SUBJECT: COMANCHE PEAK STEAM ELECTRIC STATION
DOCKET NOS. 50-445 AND 50-446
SUPPLEMENT TO LICENSE AMENDMENT REQUEST (LAR) 07-004
REVISION TO THE OPERATING LICENSE AND TECHNICAL SPECIFICATION 1.0,
"USE AND APPLICATION" TO REVISE RATED THERMAL POWER FROM 3458 MWT
TO 3612 MWT
(TAC NOS. MD6615 AND MD6616)

RESPONSE TO REQUEST FOR ADDITIONAL INFORMATION

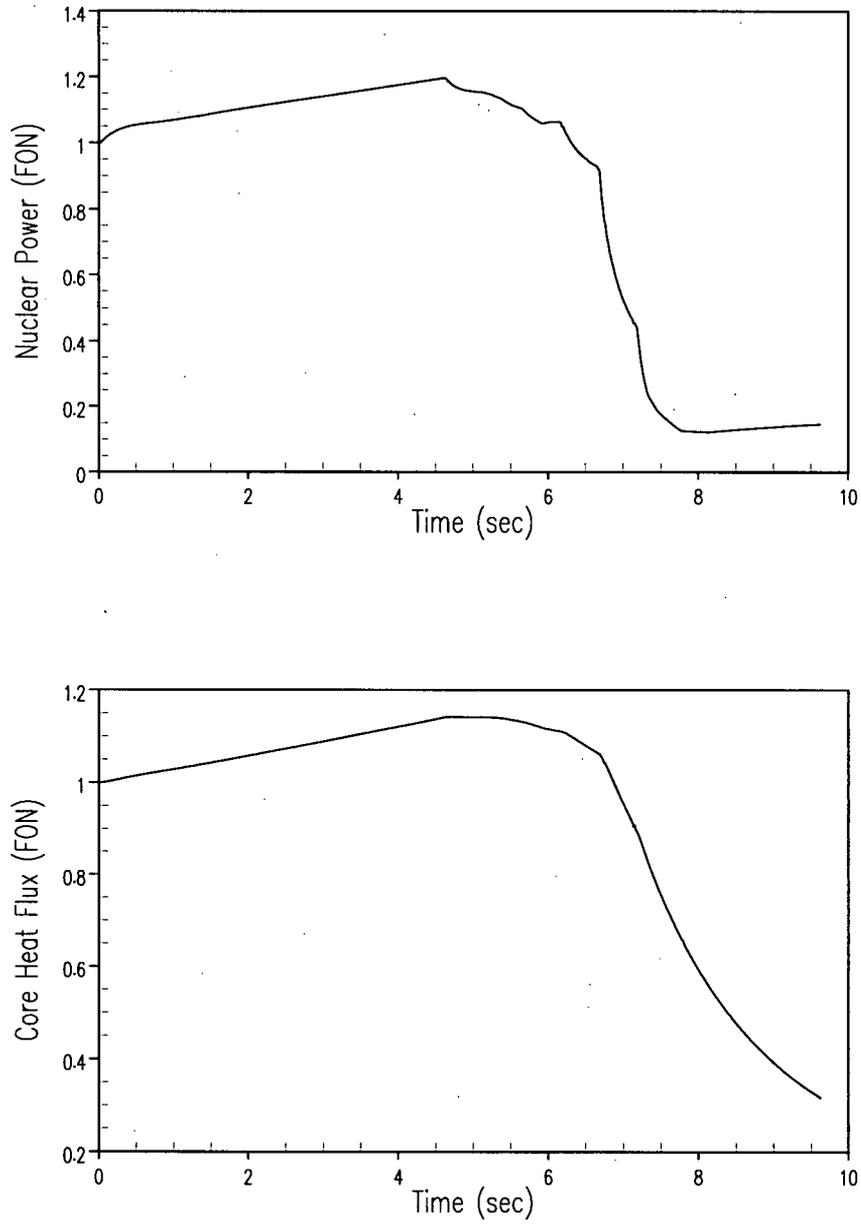
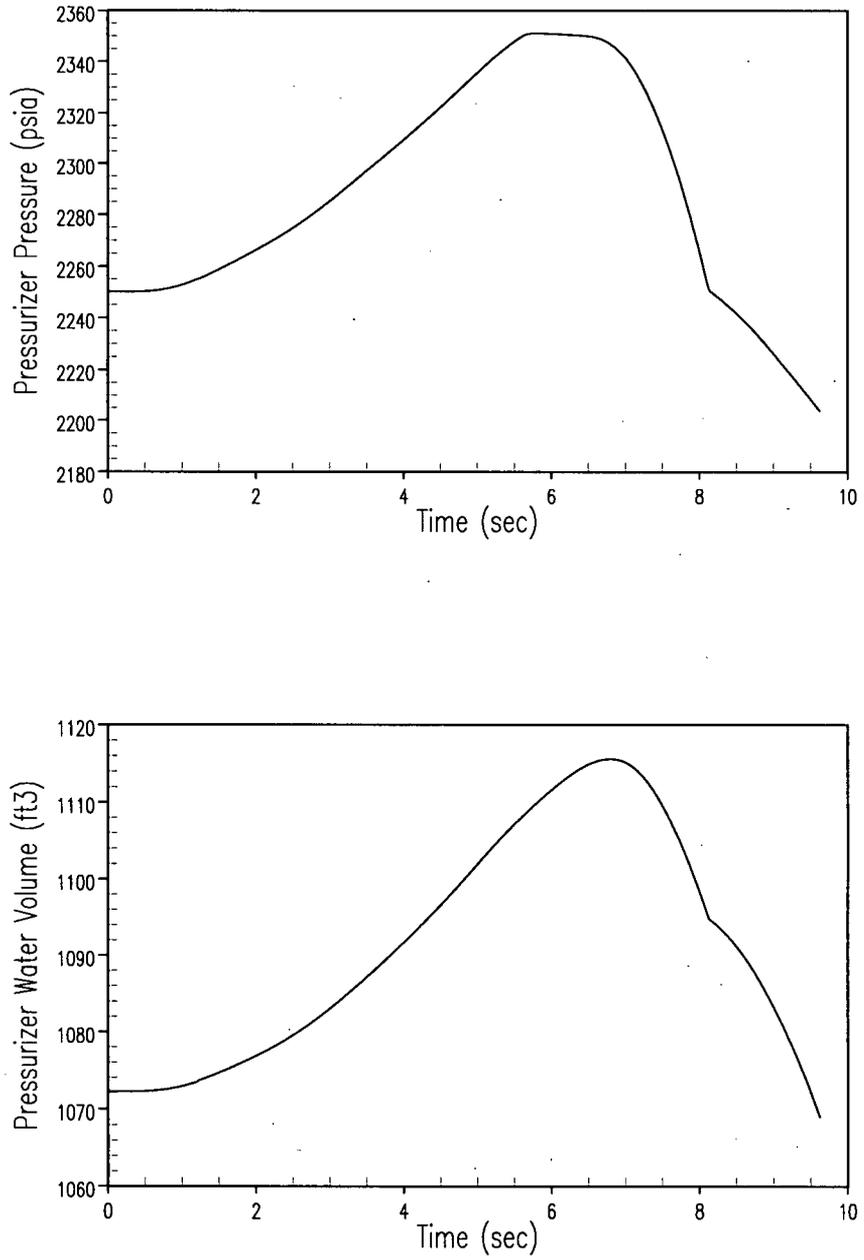
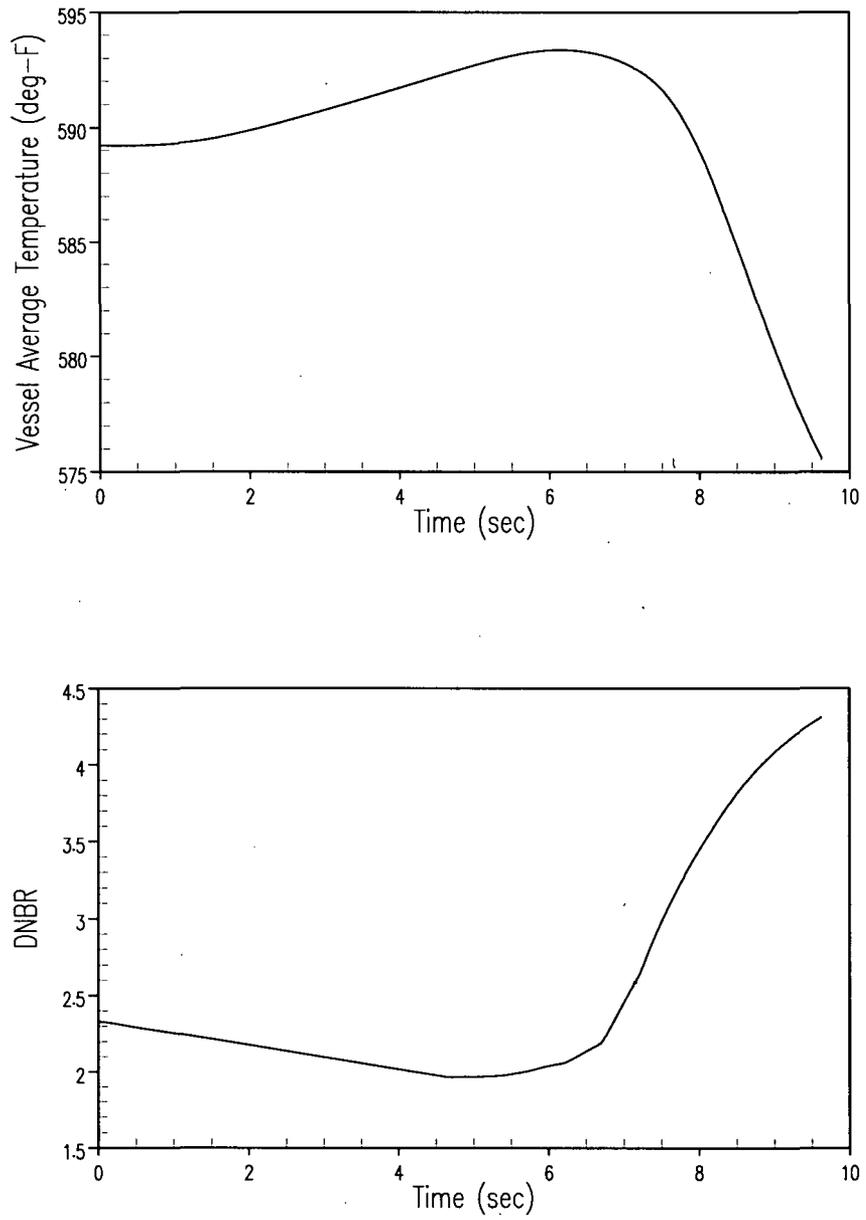
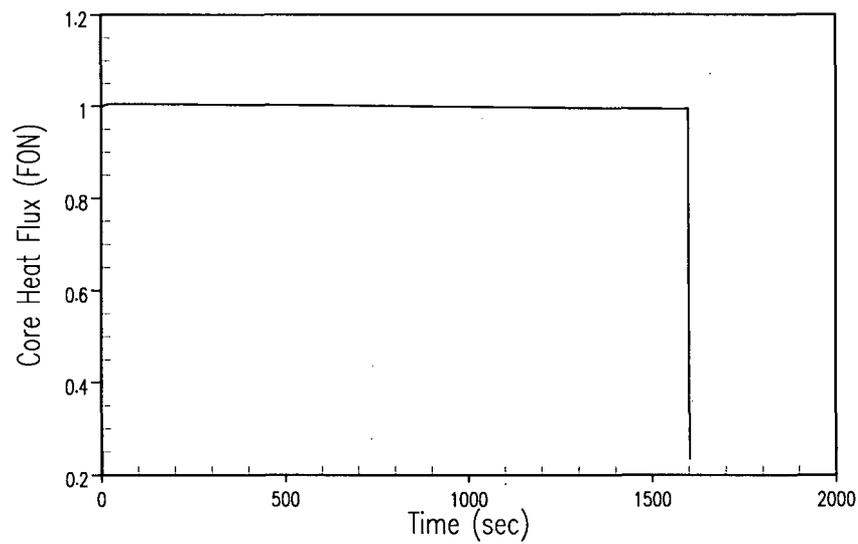
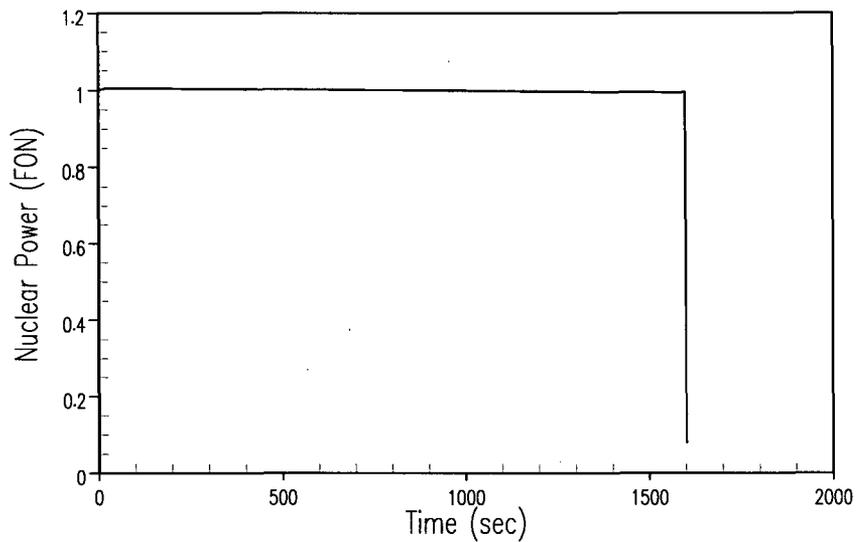
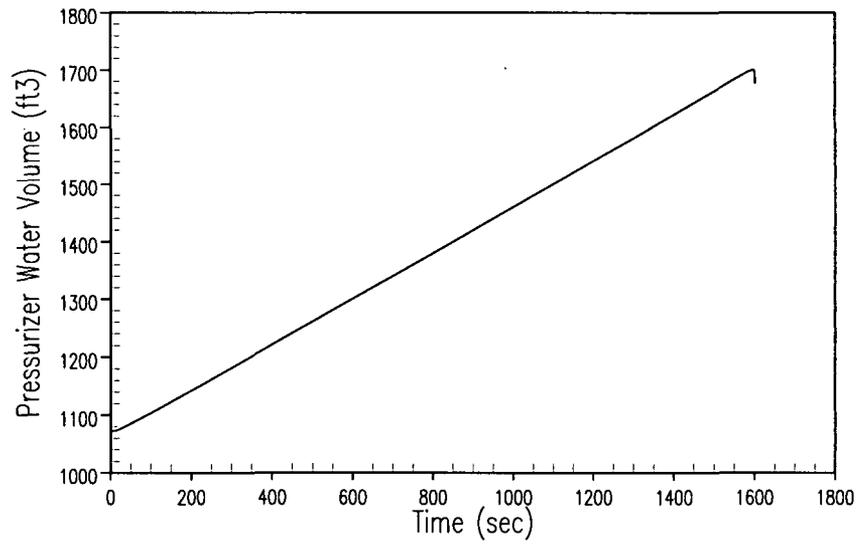
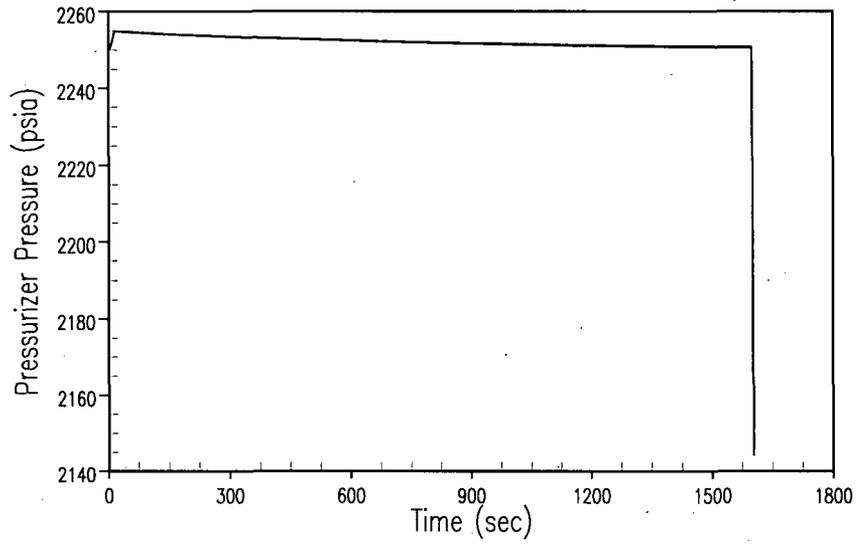
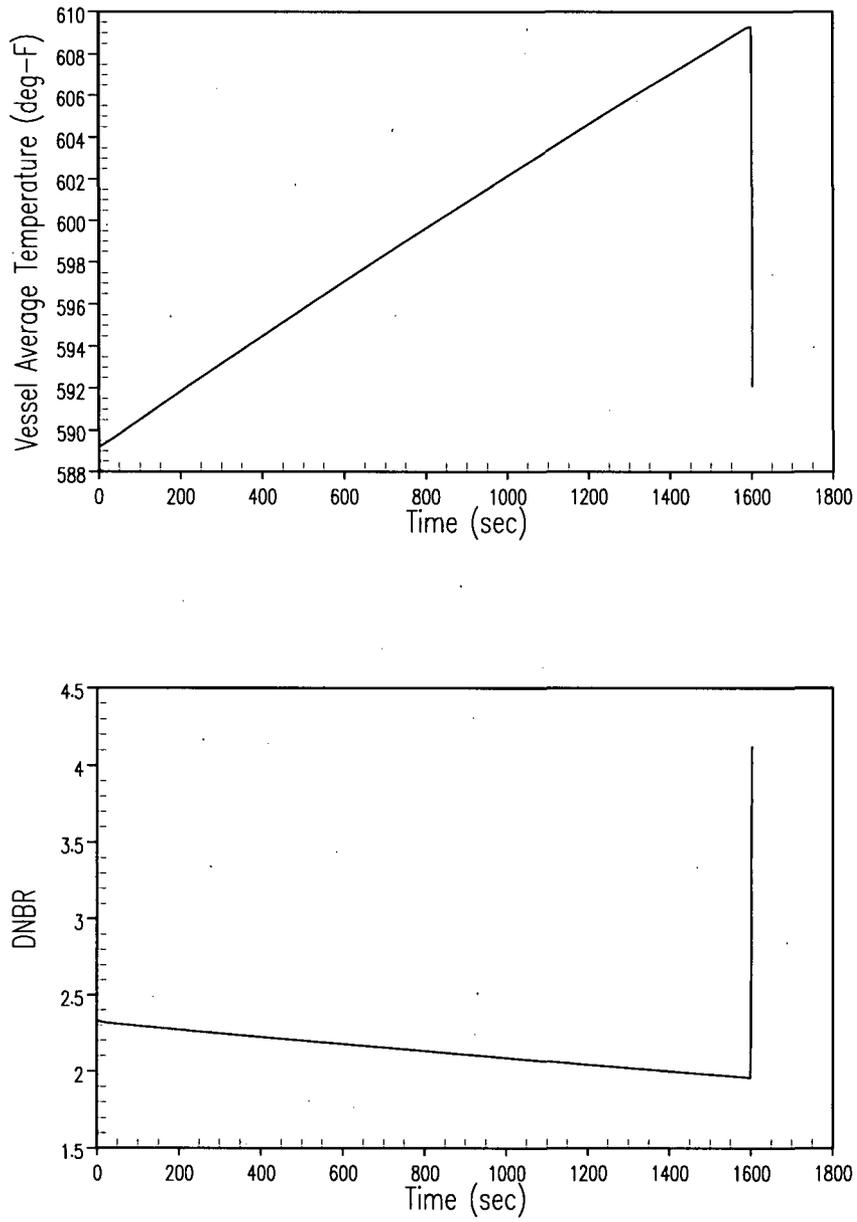
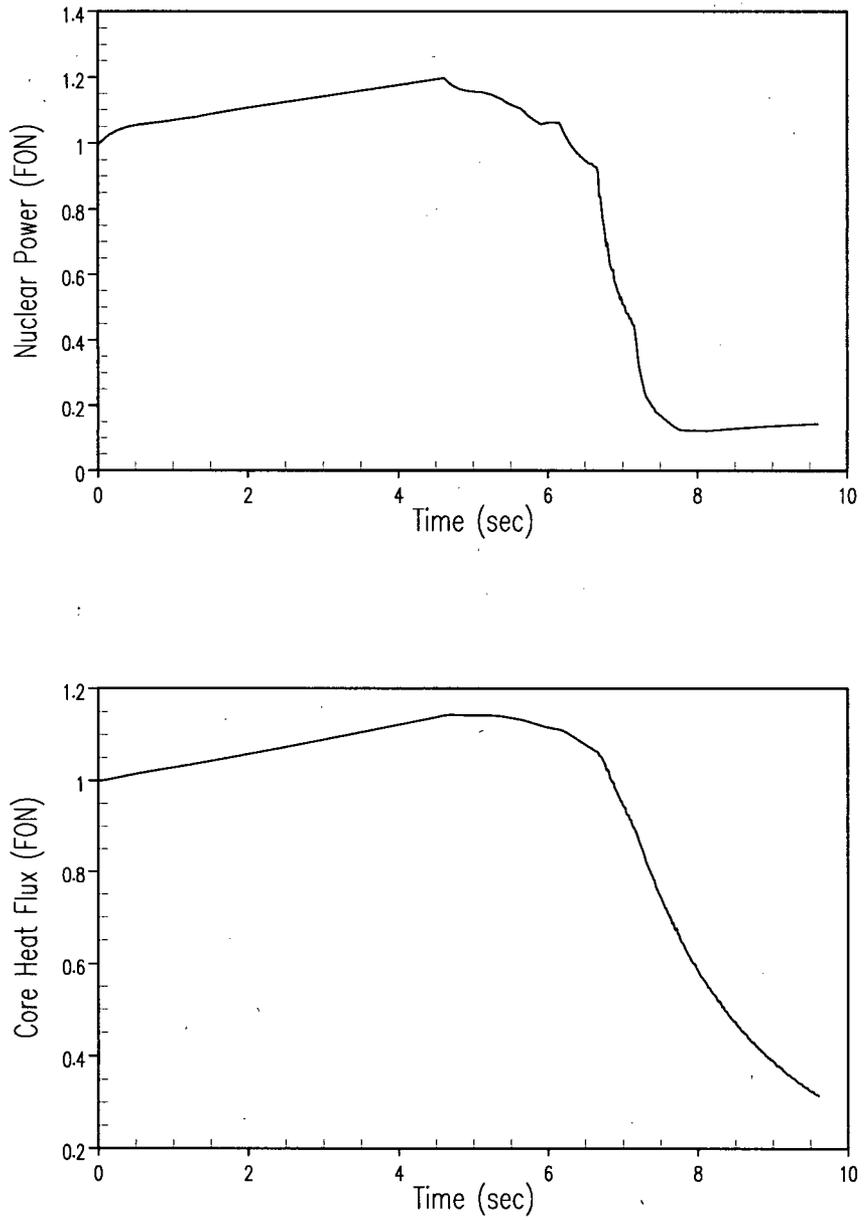
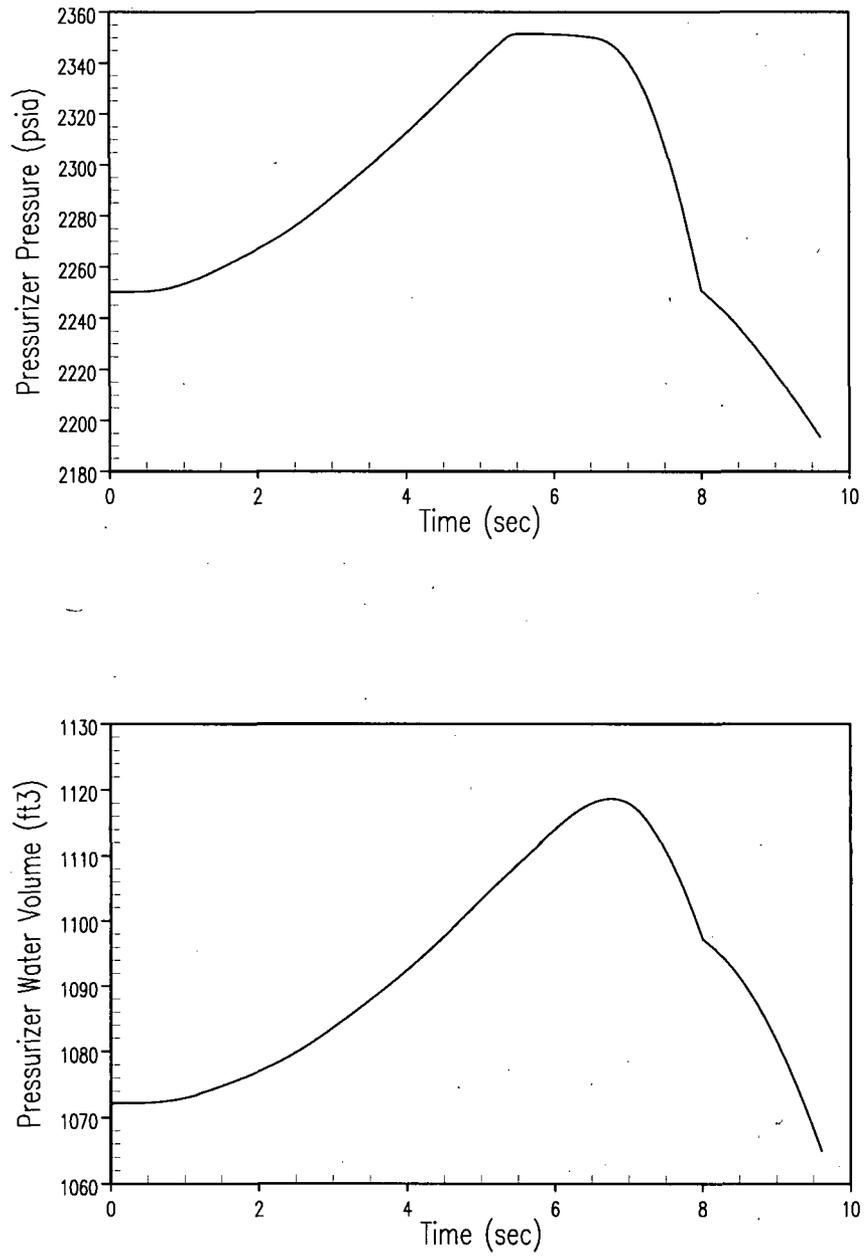
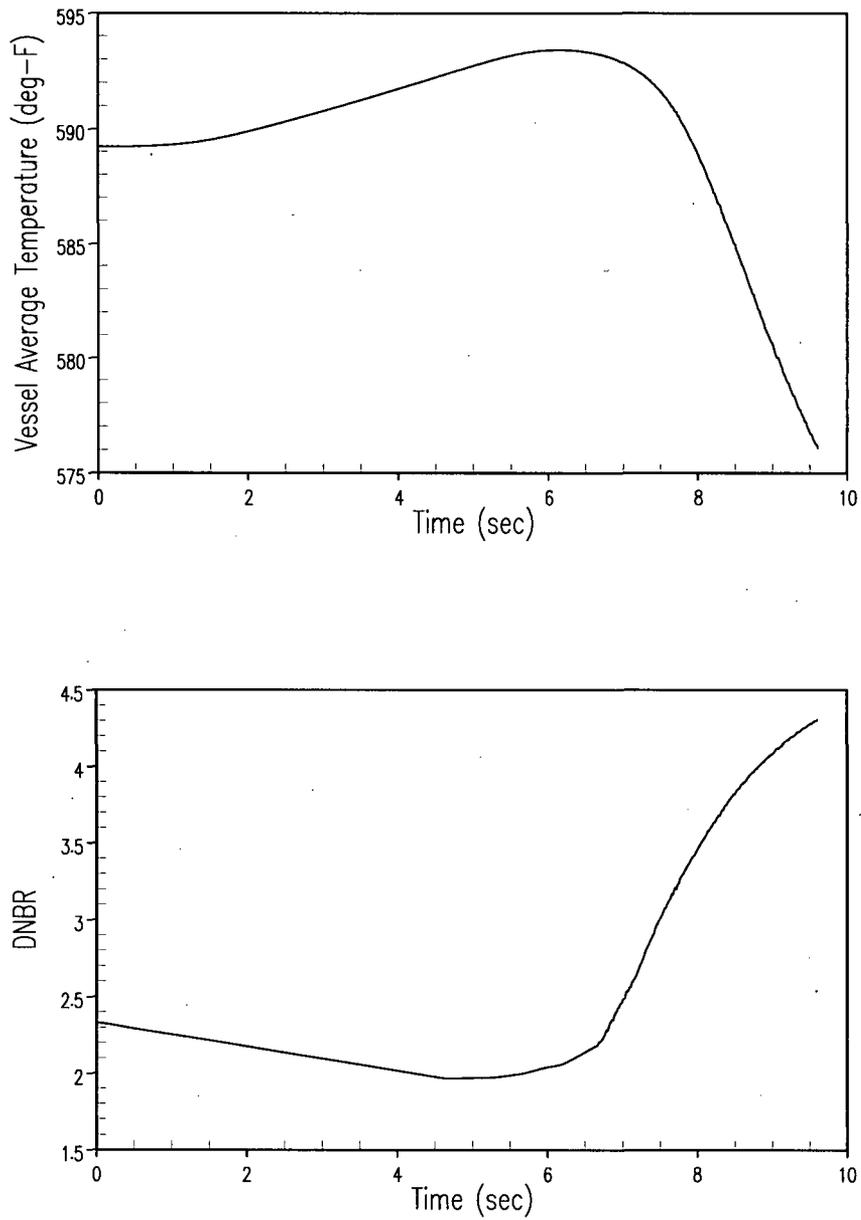
The SPULR states that two cases for minimum and maximum reactivity feedback were analyzed. The staff was unable to locate the results for the maximum reactivity feedback case. Provide these results.

The requested results are provided in the attached revision to Section 2.8.5.4.2 (Uncontrolled Rod Cluster Control Assembly Bank Withdrawal at Power). This section was recently revised to address some isolated issues related to the corresponding analysis. As the revised analysis affected results that were presented in Table 2.8.5.0-1, Table 2.8.5.4.2-1, and Table 2.8.5.4.5-1 (Boron Dilution) of the licensing report, revised tables are also provided (See Attachments 2 and 3).

Figures 2.8.5.4.2-7 through 2.8.5.4.2-9 (Unit 1) and Figures 2.8.5.4.2-22 through Figures 2.8.5.4.2-24 for (Unit 2) show the transient response for a rapid uncontrolled RCCA bank withdrawal incident (110 pcm/sec) starting from 100 percent power with maximum reactivity feedback. The transient response for a slow uncontrolled RCCA bank withdrawal (1 pcm/sec) from 100 percent power with maximum feedback is shown in Figures 2.8.5.4.2-10 through 2.8.5.4.2-12 (Unit 1) and Figures 2.8.5.4.2-25 through 2.8.5.4.2-27 (Unit 2). The results are similar to the results of the cases with minimum reactivity feedback, but the maximum reactivity feedback leads to a slower increase in power, resulting in a longer transient.
